REVISED STAFF REPORT: 11/08/2023 MEETING

APPLICATION NUMBER: HDC2023-~~0085~~00093

ADDRESS: 400 FISKE

SCOPE OF WORK: REPLACE SLATE ROOF WITH ASPHALT SHINGLES (WORK PARTIALLY COMPLETE)

400 Fiske, current. Staff photo taken 11/1/2023, facing southeast

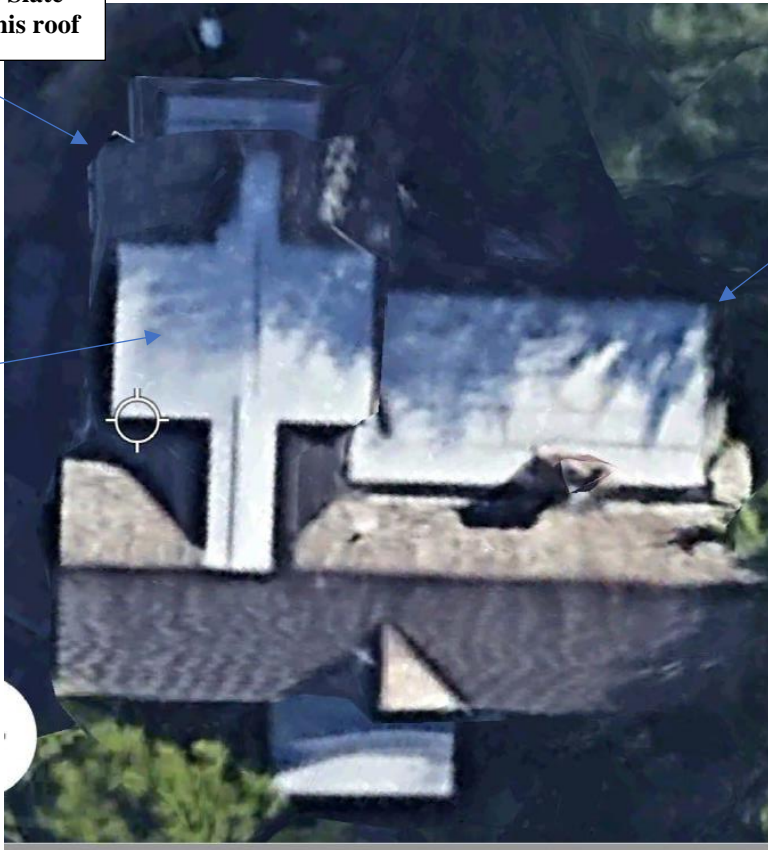
Erected ca. 1925, the building at 400 Fiske is a two-story, single-family dwelling that is located within the Berry Subdivision Historic District. The Tudor Revival-style house displays a cross-gabled roof with a side-gabled, two-story central/main mass and an intersection projecting gabled wing at the rear. A two-story wing with a mansard type roof is also located at the building's rear. The slate has been removed from the side-gabled, main portion of the roof. Newly installed brown asphalt shingles or underlayment has been installed at this portion of the roof. The intersecting projecting rear gabled roof retains the original slate. The shed-roof dormers which top this portion of the roof displays slate at their front and side walls. Exterior walls of the home are clad with stucco and brick. Wood half-timber detailing is located at the building's second story. Windows are the historic-age wood double hung and casement units. An historic-age, detached garage which sits to the rear of the parcel displays a brick exterior cladding and a hipped slate roof.

- As noted above, the slate roof has been removed from the main, side-gabled portion of the roof. The portion of the rear, gabled roof and the shed-roof dormers retain their historic slate tiles.

- Staff did view the designation photo of the home, the remaining portions of the slate on the property's roof, and recent Google Streetview images which were taken prior to the current unapproved roof removal. It is staff's opinion that the slate roof was a distinctive, character-defining feature of the home.

Aerial photo of roof. Photo provided by applicant

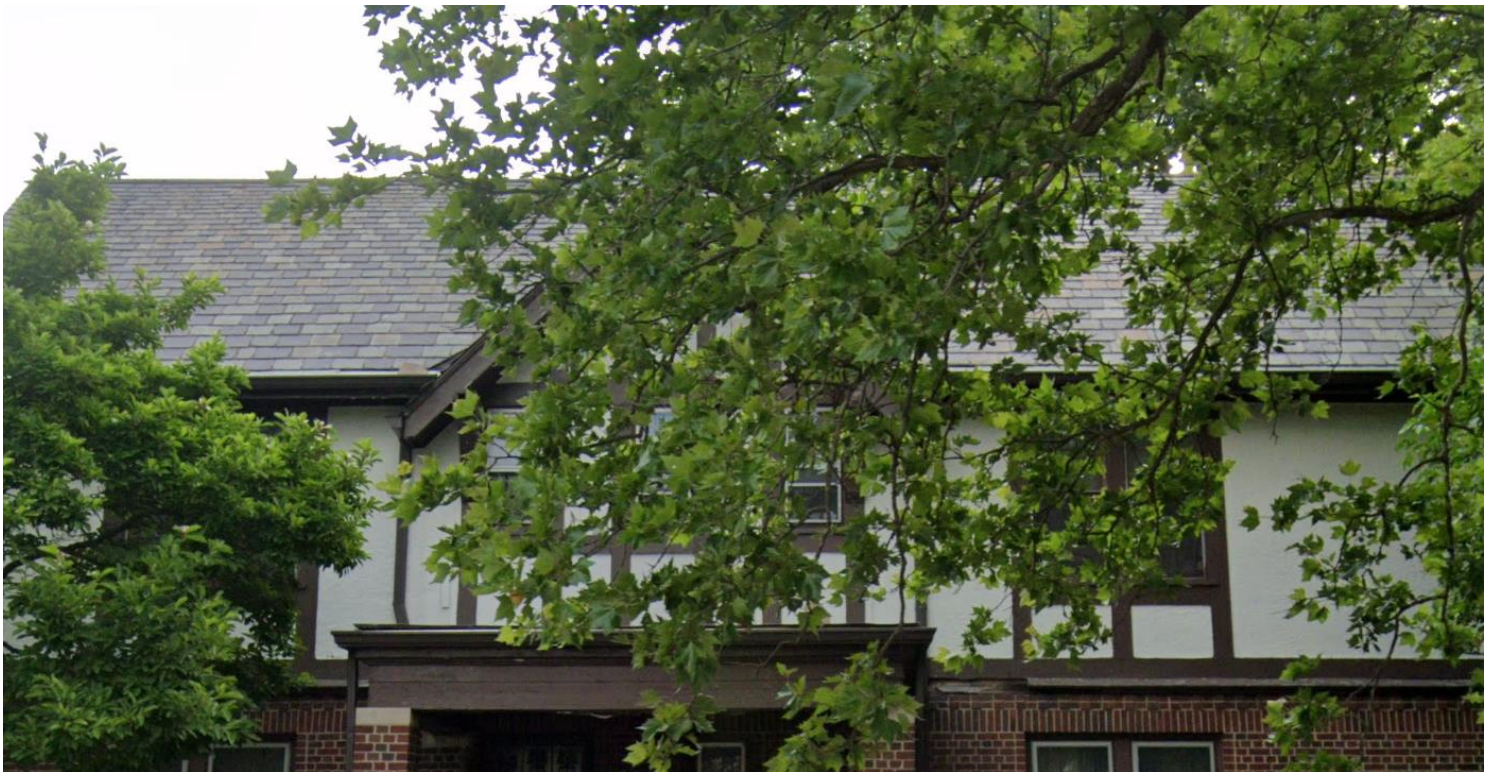
Rear of main side-gabled roof, south portion, facing northwest. Current conditions. Note that the slate has been removed and the area has been covered/weatherproofed with underlayment. Photo provided by applicant

Rear gabled wing and dormer, showing current conditions, facing southeast. Photo taken on 11/1/2023 by staff

Rear gabled wing and dormer, showing current conditions, facing northwest. Photo taken by applicant

Detailed photos of the remaining slate at the rear roof and dormers, provided by applicant

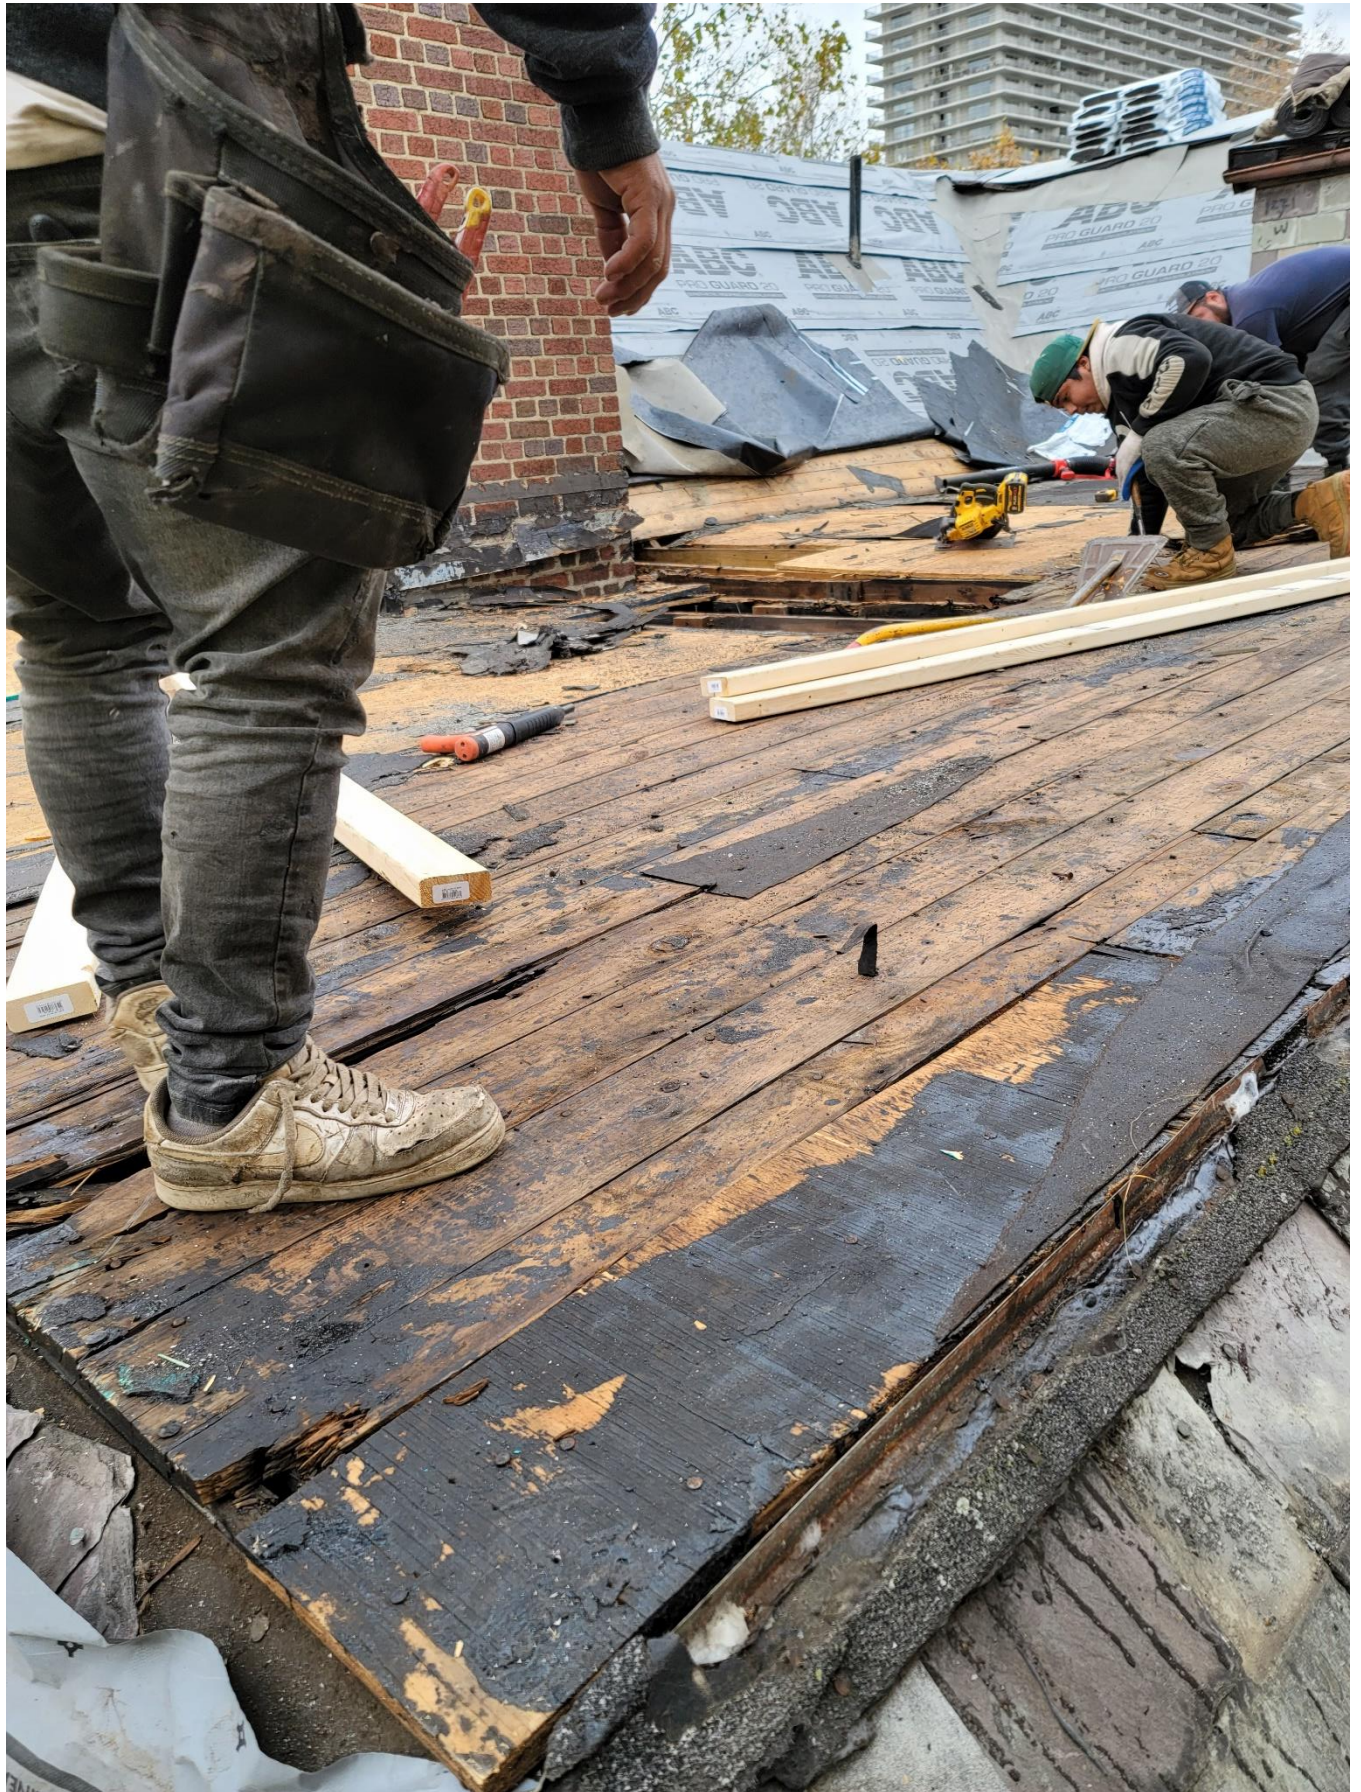
- Additional annotated exterior photos and interior photos
- In an email dated 11/7/2023, the applicant has indicated that “the Slate that's on the Dormer the back part of the house the Slate is in good condition it can be saved it was just based on making the house uniform instead of shingles and slate is based on your guy's decision but the repair parts of the Slate on the Dormer and the back area of the lower part of the house can be repaired we will have to purchase the slate no more than eight \$900 but the slate is in good condition”

- An email which the applicant sent on 11/8/2023 states that “only 10 to 20% of the Slate as damage crack missing areas but it can be replaced and repaired of the remaining tiles.” This email was referring to the remaining slate at the rear roof gabled wing

- In an email dated 11/8/2023, the applicant stated that he had discovered that the wood behind the slate shingles at the dormer is rotted. He has provided photos of the decking at the flat roof, adjacent to the south dormer to demonstrate the condition of the wood beneath the dormer’s slate tiles (see below).

- The applicant has provided a narrative description/condition assessment ~~and limited photos (from the ground) of the remaining areas of slate at the roof. Staff does accept the applicant's assessment that the remaining areas of slate are generally deteriorated to an extent that merits replacement.~~ The applicant has also provided additional photos of the roof (see below). As noted above, the applicant has indicated that the remaining slate roof (at the dormers and rear portion of the house) is in good condition and can be repaired. He gives a quote of \$900 for that repair, but staff questions the estimate as he also has noted that portions of the slate were damaged by a previous contractor.
